5 Government submissions

This chapter provides a summary and response to the eight local and State government submissions (including interagencies) received on the proposed modification.

HVO South Modification 5

Response to submissions

Figure 5.2

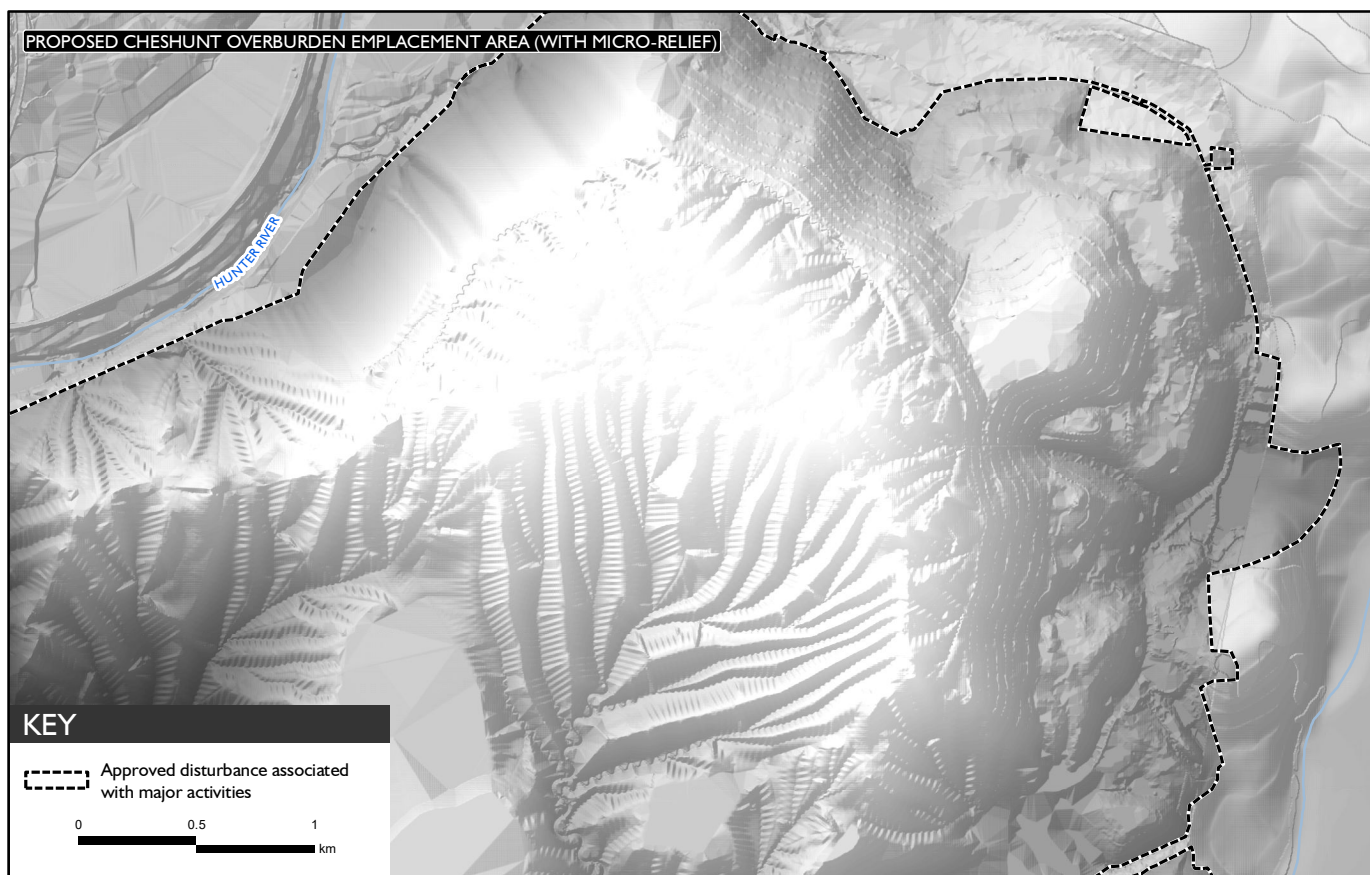
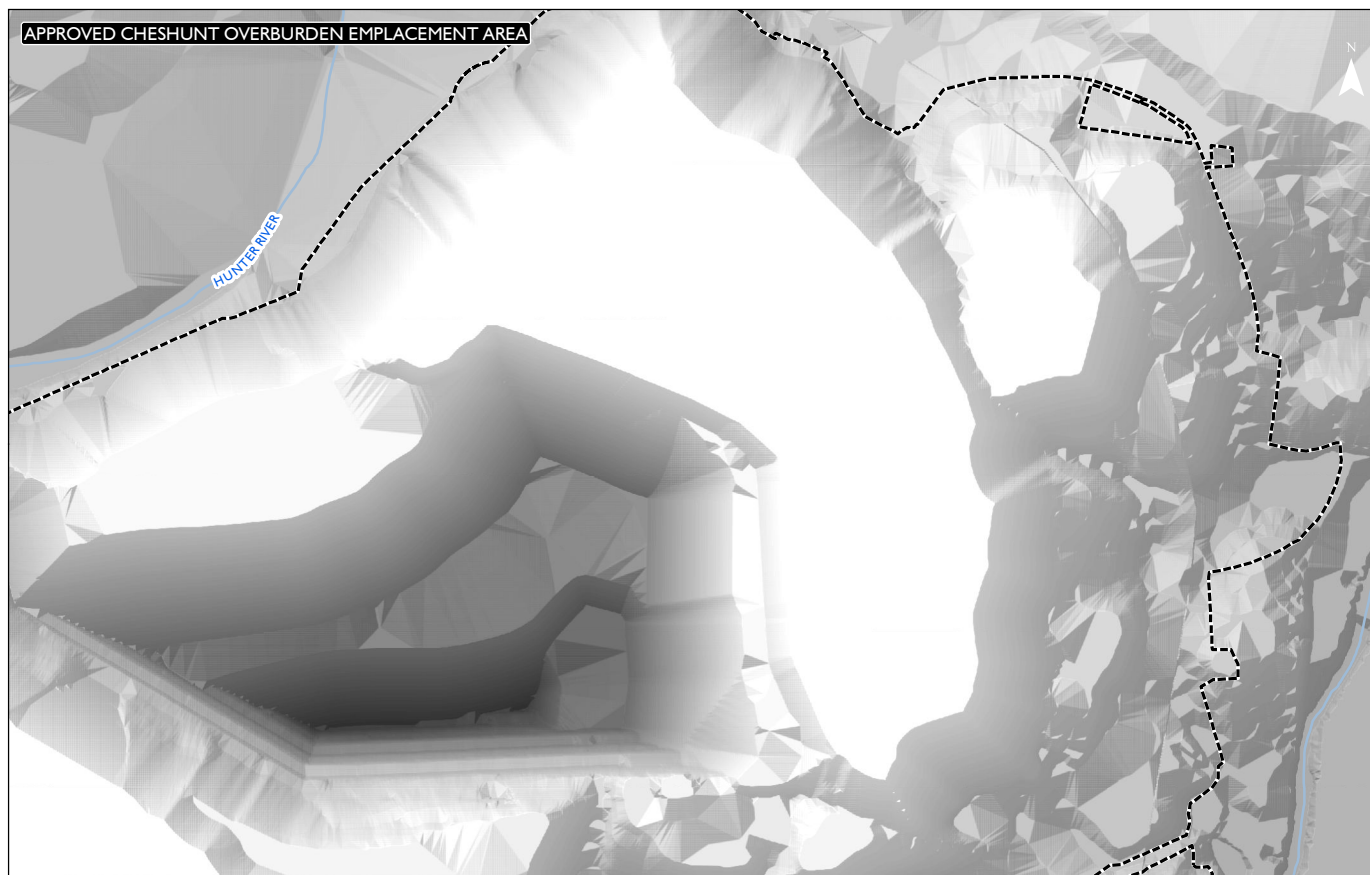
The DPE noted that the proposed design of the overburden emplacement area represents a substantial improvement to the traditional design and methods. The submission requested that Coal & Allied consider opportunities for further refinements, such as incorporating more topographic variation to the external slopes of the emplacement areas to improve visual amenity. DPE stated that the northern area of the Cheshunt overburden emplacement area appeared to have minimal macro-relief and may represent an opportunity for further refinement.

In response to the DPE request, Figure 3.3 of this RTS has been prepared to illustrate the stylised macro-relief at a 1:1 scale. Figure 5.2 has been prepared at a finer scale to assist with visualising the topographical relief in the northern area of the Cheshunt overburden emplacement area.

In addition to micro-relief, the proposed final landform also comprises some macro-relief within its design. Macro-relief of overburden emplacement areas is generally visible at distance rather than at closer proximity. This is shown in photomontages presented within the EA for viewpoints at Knodlers Lane (Figure 9.5) and Long Point (Figure 9.7), which are 3.6km and 7km from the Cheshunt overburden emplacement area, respectively. Viewers from Long Point are able to more readily view the macro-relief within the final landform than those in closer proximity at Knodlers Lane due to the increased setback.

Figure 5.3

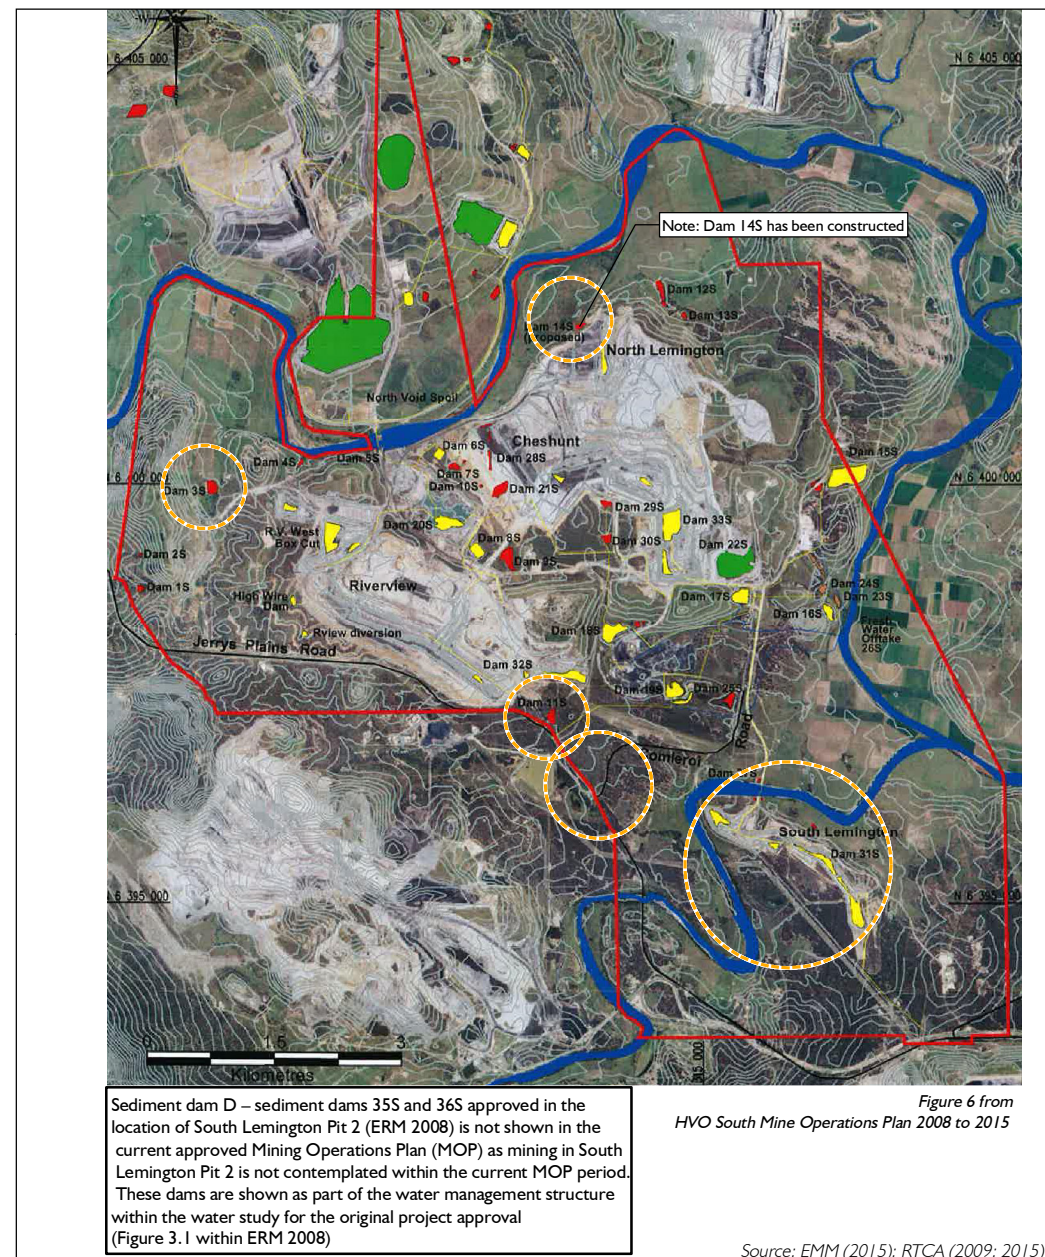
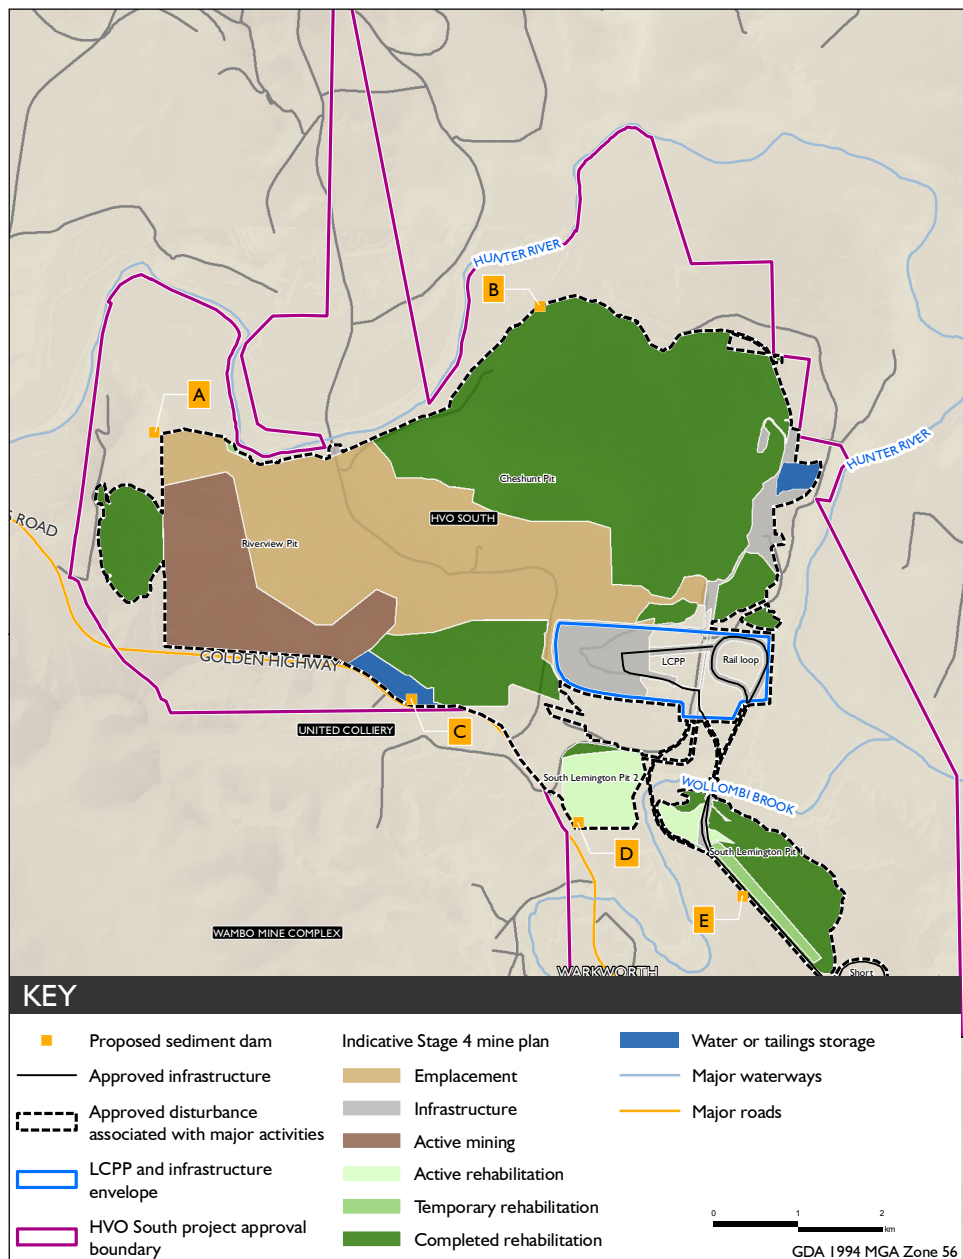
The DPI Water submission noted the water balance study within the EA (HATCH 2016) stated that the proposed modification included five nominal locations where sediment dams would be constructed. DPI Water requested further information on these sediment dams.

These structures (as presented in the proposed modification) perform the same function as structures previously presented in the approved mine plan and the approved Mining Operations Plan (MOP). This is shown in Figure 5.3 and described in Table 5.4 below.

Location (refer to Figure 5.3)	Approved mine plan	Proposed modification
A	Dam 3S	Sediment Dam A functionally corresponds to Dam 3S (approved structure), however the location will be moved to the northernmost extent of the proposed modification mine plan.
B	Dam 14S	Sediment Dam B functionally corresponds to Dam 14S (existing approved sediment basin).
C	Dam 11S	Sediment Dam C is functionally included in the approved mine plan by redirecting the Riverview Void catchment through Dam 11S or its functional replacement, if required.
D	Dam 35S/36S	Sediment Dam D functionally corresponds to either Dam 35S or 36S (both presented on Figure 6 within the MOP (refer to Figure 5.3 of this RTS) and the Final Catchment Plan in the water study (ERM 2008) of the EA for the project approval).
E	Dam 31S	Sediment Dam E functionally corresponds to management intent for Dam 31S described in the Figure 6 within the MOP associated with approved final landform).
